Re: FINAL ENVIRONMENTAL ASSESSMENT CHAPTER 343,
HAWAII REVISED STATUTES (HRS)
Environmental Assessment (EA)/Determination
Finding of No Significant Impact (FONSI)

**FINAL
ENVIRONMENTAL ASSESSMENT AND
COASTAL ENGINEERING EVALUATION FOR
SHORELINE SETBACK VARIANCE APPLICATION**

TMK: 5-5-02:5
55-295 Kamehameha Highway
Laie, Oahu, Hawaii

Review Comment and Response Letters

FIGURE 3-1. SHORE AND NEARSHORE CHARACTERISTICS
(from AECOS, 1981)

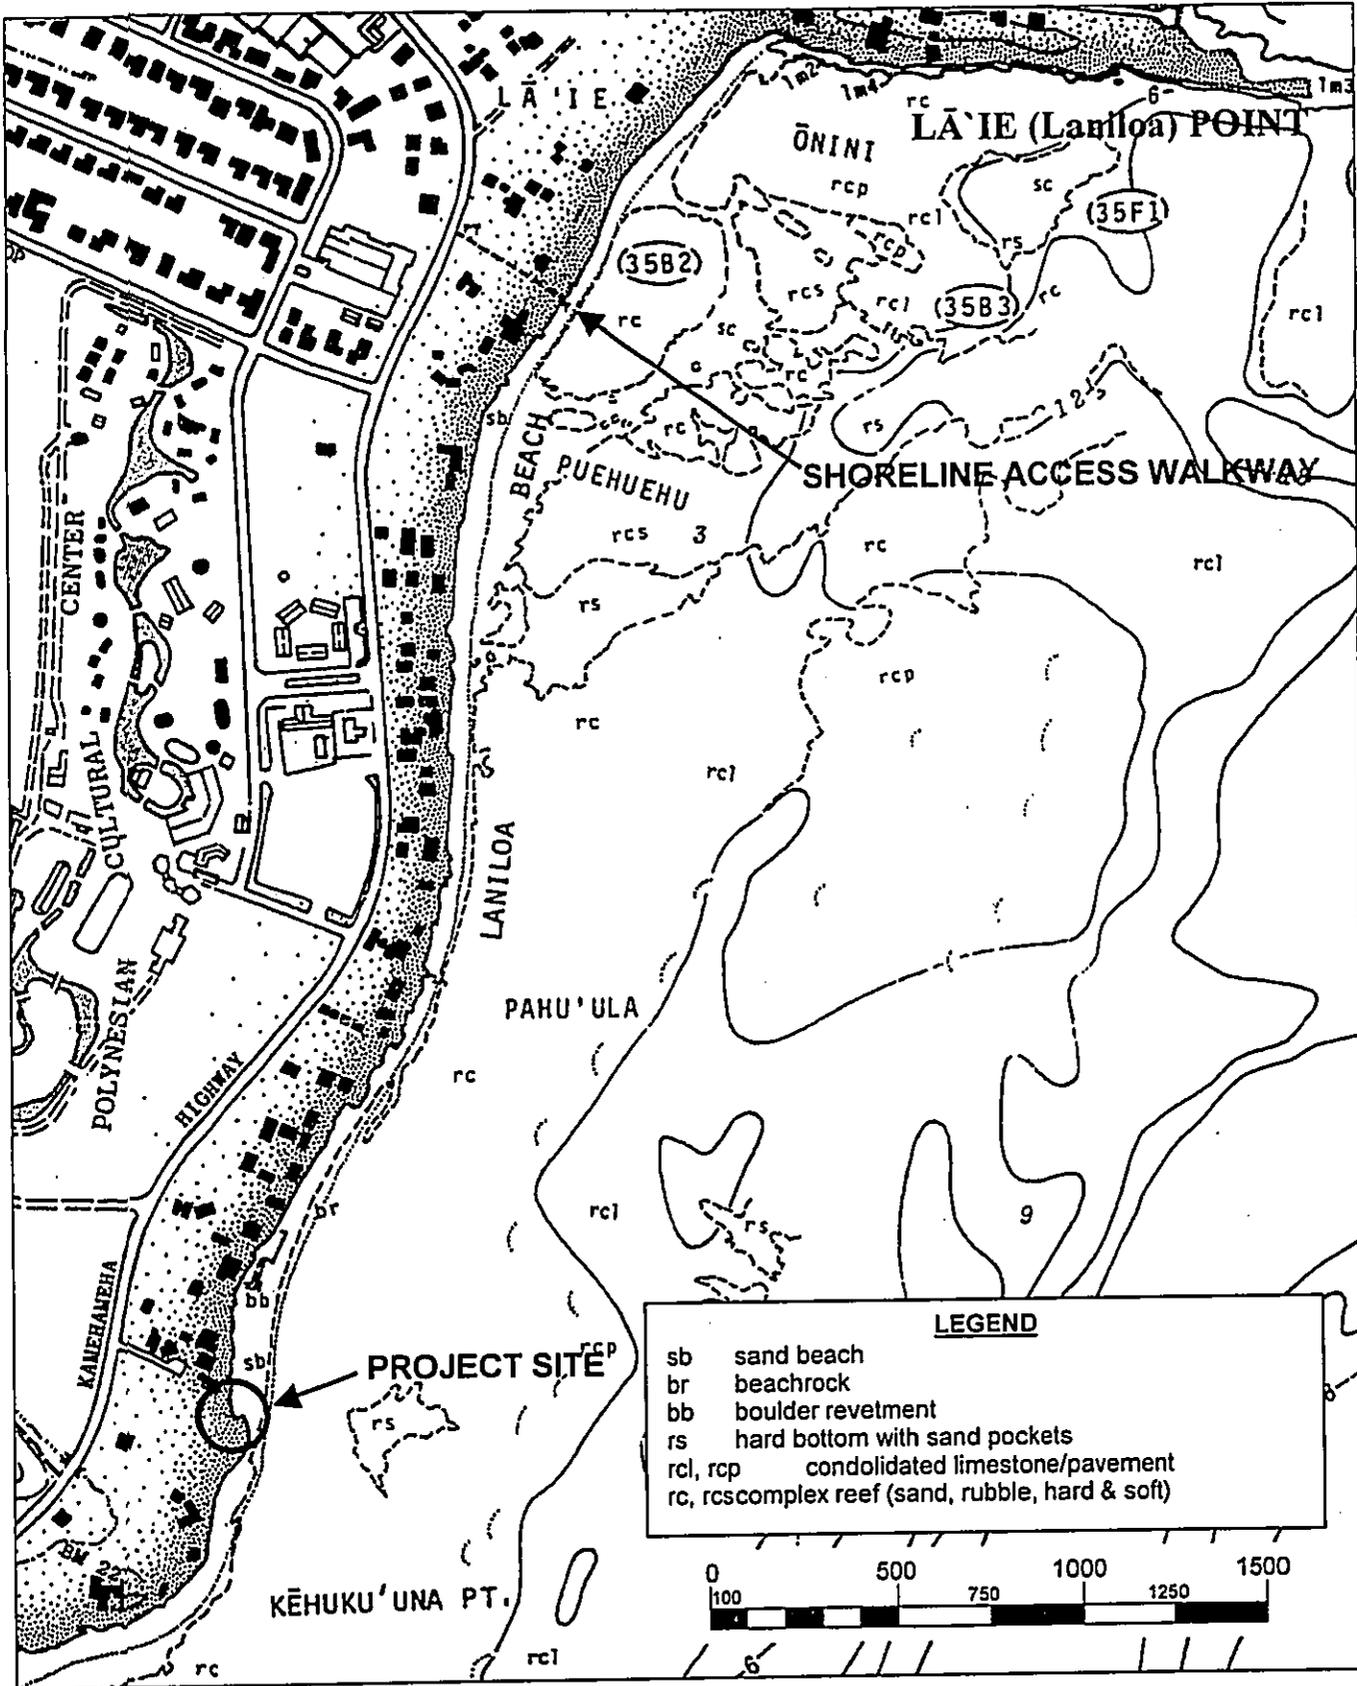
The nature of the nearest public shoreline access should be clarified (i.e., beach park, pedestrian right-of-way, etc.) and indicated on Figure 3.1.

The nature of the public access to Laniloa Beach has been added to the FEA, and its location has been shown on Figure 3.1. Discussion of "Pounders" public beach park 2,000 feet south of the project site has also been added to the FEA.
